Access Compliance Report

Public Rights-of-Way

Intersection ID: 23966	Main Street: CAROLINA PAVILION DR N	Cross Street: SOUTH BV	Location: NW
ADA ID: 8F0CEBE3B9E9	Ramp Type: Perpendicular	Initial Pass/Fail: Fail	Overall Compliance: No
Severity Score: 13.75			
Codes/Mitigation Info/Possible Solution		Field Measurements/Component Compliance

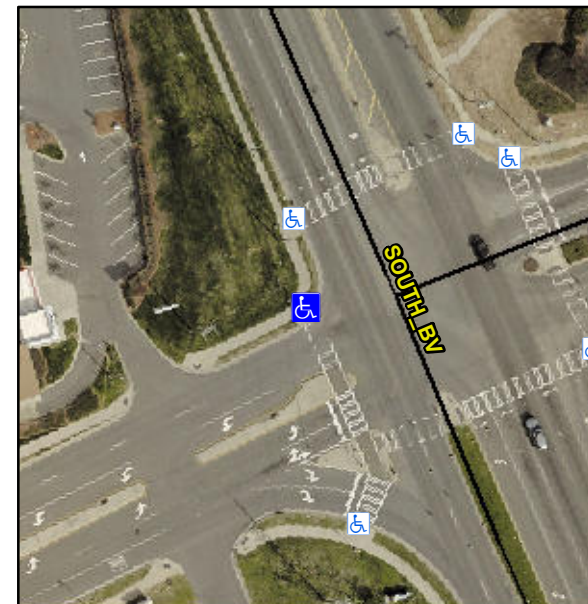
Not Found, R304.2.2

Compliance	Description	Data	Compliance	Description	Data
N/A	Ramp Length (in)	48.0	No	Ramp Slope (%)	8.6
Yes	Ramp Width (in)	48.0	Yes	Ramp XSlope (%)	3.2
N/A	Flare Type LT	N/A	N/A	Flare Type RT	N/A
N/A	Flare Slope LT (%)	N/A	N/A	Flare Slope RT (%)	N/A
N/A	Flare Traversable LT?	N/A	N/A	Flare Traversable RT?	N/A
N/A	Landing Length (in)	N/A	N/A	DWS Provided?	N/A
N/A	Landing Width (in)	N/A	N/A	DWS Contrast?	N/A
N/A	Landing Slope (%)	N/A	N/A	DWS Length (in)	N/A
N/A	Landing X Slope (%)	N/A	N/A	DWS Full Width?	N/A
N/A	Landing Curb? (Y/N)	N/A	N/A	DWS Offset (in)	N/A
N/A	Shared Landing?	N/A			
N/A	Gutter Ponding?	N/A	N/A	Gutter Slope (%)	N/A
N/A	Gutter Lip Ht (in)	N/A	N/A	Gutter X Slope (%)	N/A
N/A	Painted X Walk1?	Yes	N/A	Painted X Walk2?	N/A
	X Walk 1 Direction	To S		X Walk 2 Direction	N/A
N/A	X Walk 1 Width (in)	98.0	N/A	X Walk 2 Width (in)	N/A
	X Walk 1 Slope (%)	1.9		X Walk 2 Slope (%)	N/A
	X Walk 1 X Slope (%)	3.8		X Walk 2 X Slope (%)	N/A

Remove & Replace Entire Ramp.
